MEMORANDUM

TO: PLANNING COMMISSION
FROM: KEN ONDICH, COMMUNITY DEVELOPMENT DIRECTOR
EVAN GARIEPY, PLANNER
SUBJECT: CONCEPT REVIEW OF HARVEST FIELDS SINGLE FAMILY RESIDENTIAL DEVELOPMENT CONSISTING OF 185 LOTS ON 63.05 ACRES ON LAND GUIDED AS R1 SINGLE FAMILY RESIDENTIAL AND RM MEDIUM DENSITY RESIDENTIAL, AS PROPOSED BY JPB LAND, LLC, APPLICANT.
DATE: 7/16/2026

On July 1st, 2026, City Staff received a concept review application for a proposed residential development from JPB Land, LLC named Harvest Fields. The concept plan being reviewed is labeled “Harvest Fields – Concept Plan” and is dated July 7, 2026. Additionally submitted were a “Concept Plan – Surrounding View” also dated July 7, 2026 which shows the City/County’s nearly completed Alton Ave. NE corridor study and roadway connections to confirm that the concept would fit the planned area intersections, as well as a set of slides about JPB Land and JP Brooks Builders and finally a set of slides specific to the proposed concept development for Harvest Fields. All files and documents are attached to this report.

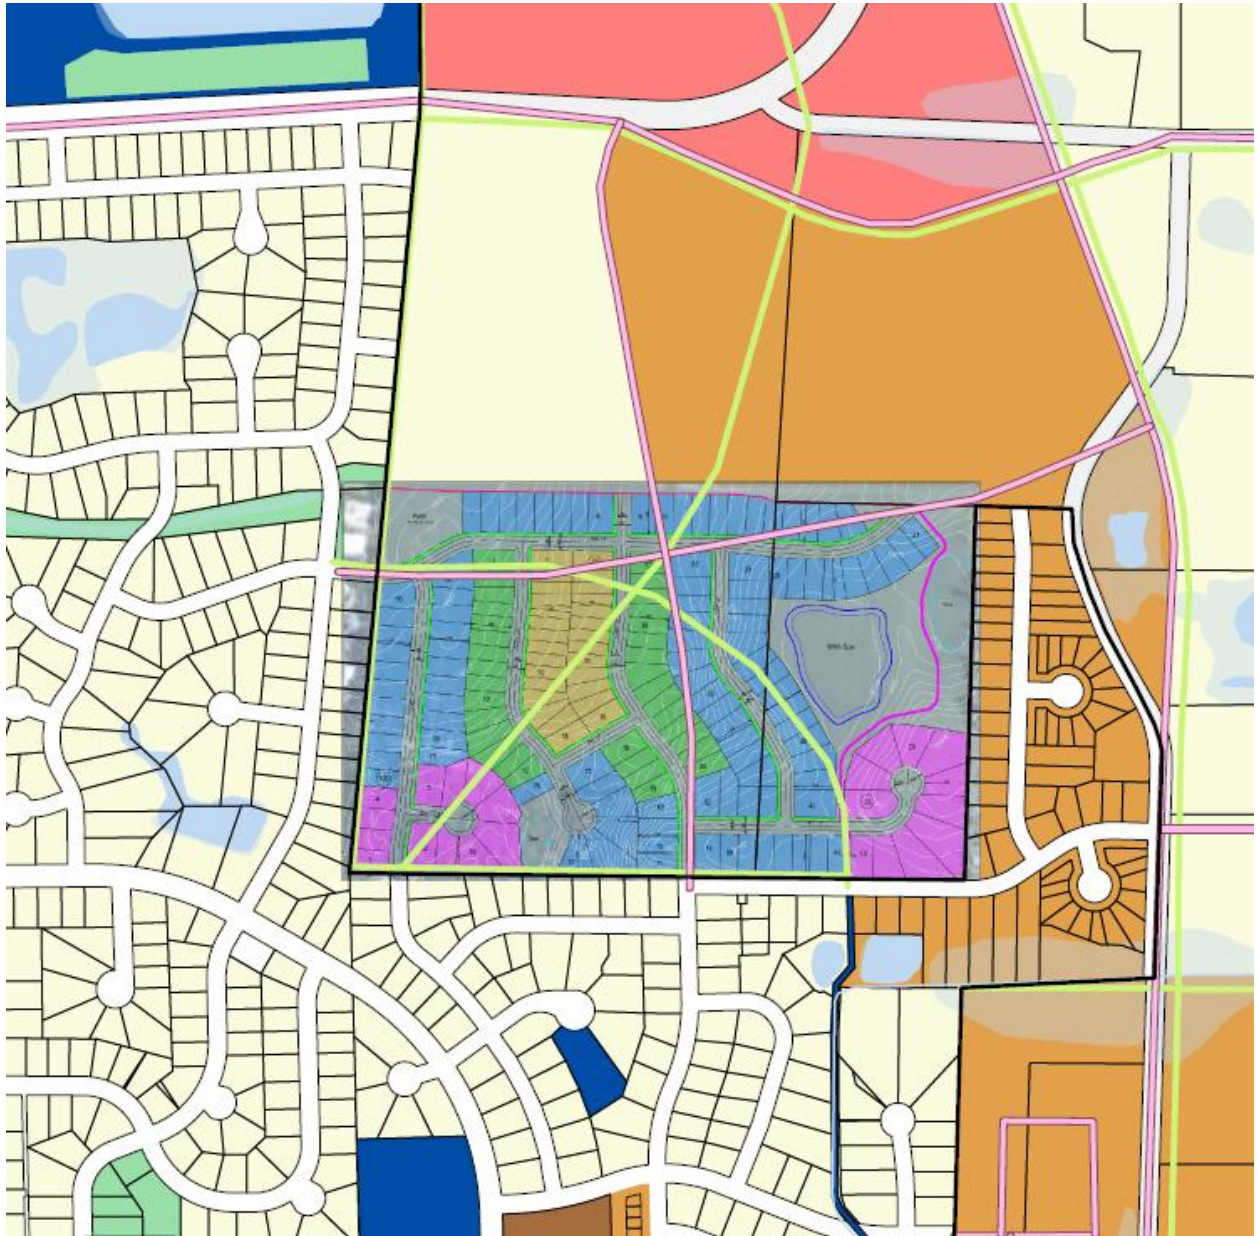
- Ladyslipper Ave. NE as a minor collector (must extend north to a previously identified connection point at 12th Street NE (CR 15) per an MOU with Scott County and Helena Township). This is also reflected in the nearly completed Alton Ave. NE corridor study update.
- Bohemia Street as a minor collector (must extend east to a previously identified connection point at Alton Ave. NE per an MOU with Scott County and Helena Township and additionally as reflected in the new study that is almost completed.)
- All other proposed roads (Ironwood Ave. NE and other unnamed) will be local roads.

Absent having a traffic impact study completed at this time, staff makes a general observation that the connections to existing Ironwood Ave. NE and Ladyslipper Ave. NE are required connections as well as Bohemia Street NE. Staff notes a general lack of alternate roadway connections to the property to the north, however, the traffic impact study will provide more insight into this topic.

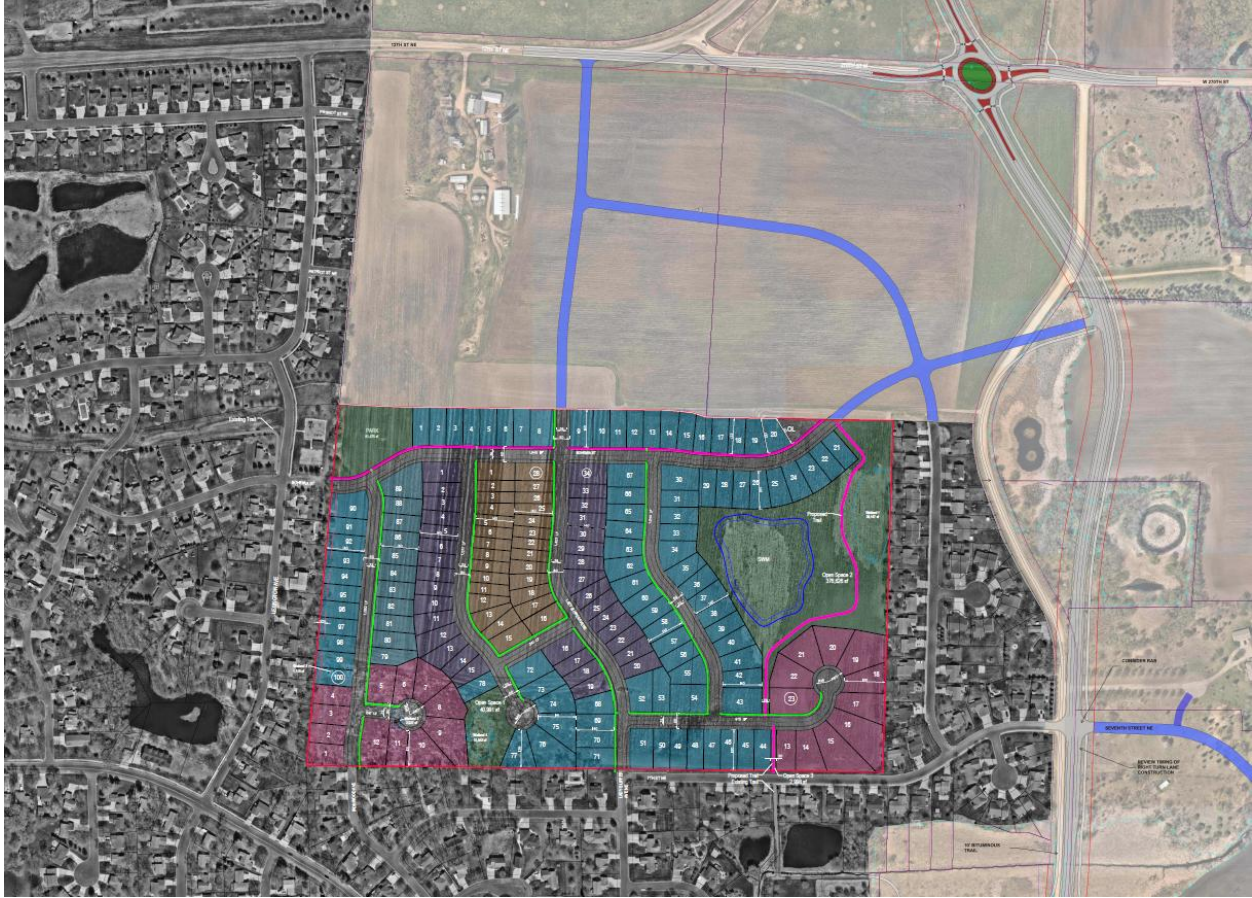
The map below shows the concept plan for the development overlaid on the still ongoing revision to the Alton Ave. NE. corridor study that is expected to be completed by the end of July 2026 between the City, County and Helena Township regarding required connection points for roadways. When said corridor study is completed, the proposed development must continue to fit into those future roadway corridors.

Also, as part of the corridor study, it is expected that a new MOU will be put into place and contain more details of possible costs to adjacent development that might occur. For this first phase of development, it would not be expected to have any impacts as it does not abut Alton Ave. NE.

HARVEST FIELDS - CONCEPT PLAN

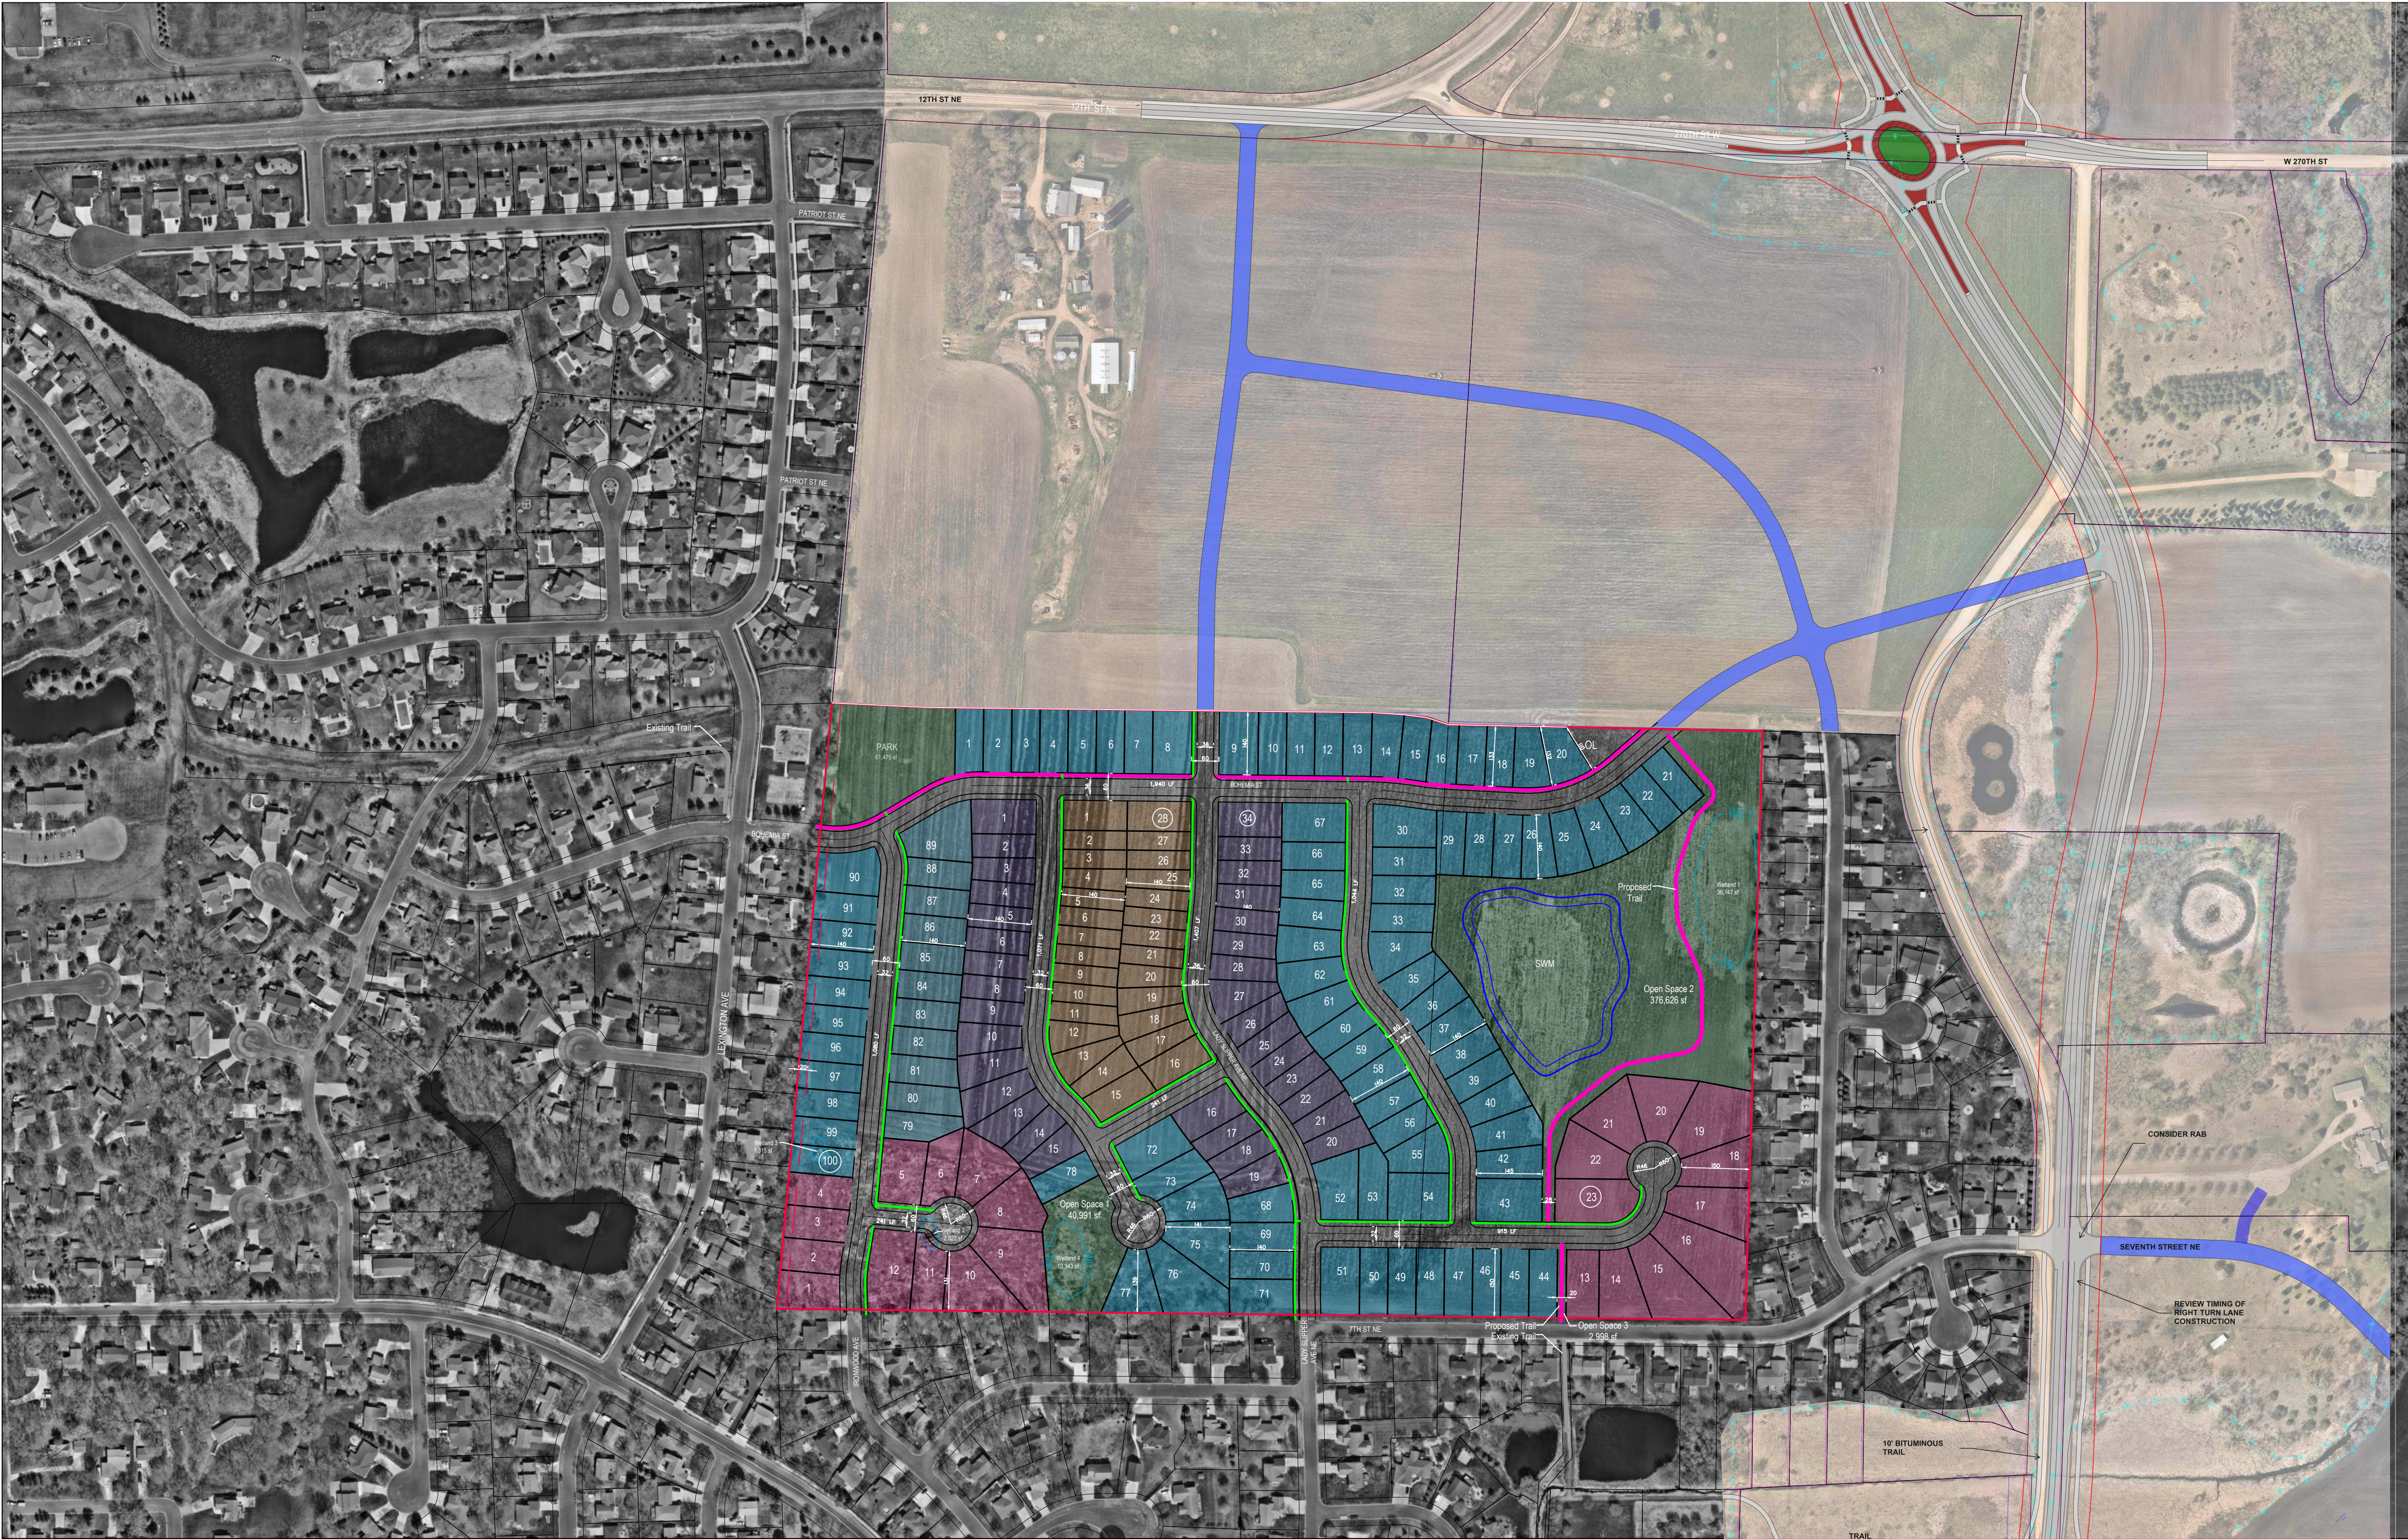
The current concept plan does not meet all of the Unified Development Code's specified density and lot size requirements. Notably, it proposes lot widths down to a width of 42' (which are 8' less than the RM district would allow by right) on up to 72' wide lots which exceed the minimum lot size for the R1 district by 12'. Additionally, a side yard reduction is sought throughout the development from 7' down to 6'. These deviations are allowed if specifically set forth in a PUD plan.

The proposed concept plan shows lots with a width of 42', 52', 62', and 72'. The lots that are 52' in width would be permitted within the RM Zoning District, and the lots that are 42' in width are not permitted by right within either the R1 or RM Zoning Districts. However, this reduction in lot width would be part of the PUD approval process. The proposed overall density is 2.93 units per acre (based on 63.05 net acres) or 3.56 units per acre based on net developable area of 51.90 acres (removing the wetlands and pond/park/open space areas).

It appears that two of the wetlands (#2 and #3 in the SW corner) would be impacted by the development and would need to be mitigated (replaced) according to WCA requirements. An application to mitigate these wetlands has not been submitted at this time.

Discussion also occurred regarding the greenway as it first enters into the development and the fact that it crosses a local street almost immediately and that the developer should look at the ability to route the greenway along the east side of the cul-de-sac to avoid the additional road crossing.

- j. Skewed trail crosswalks should be avoided. The one at 7th ST NE is okay, the one at the new road just north of 7th ST NE is not.
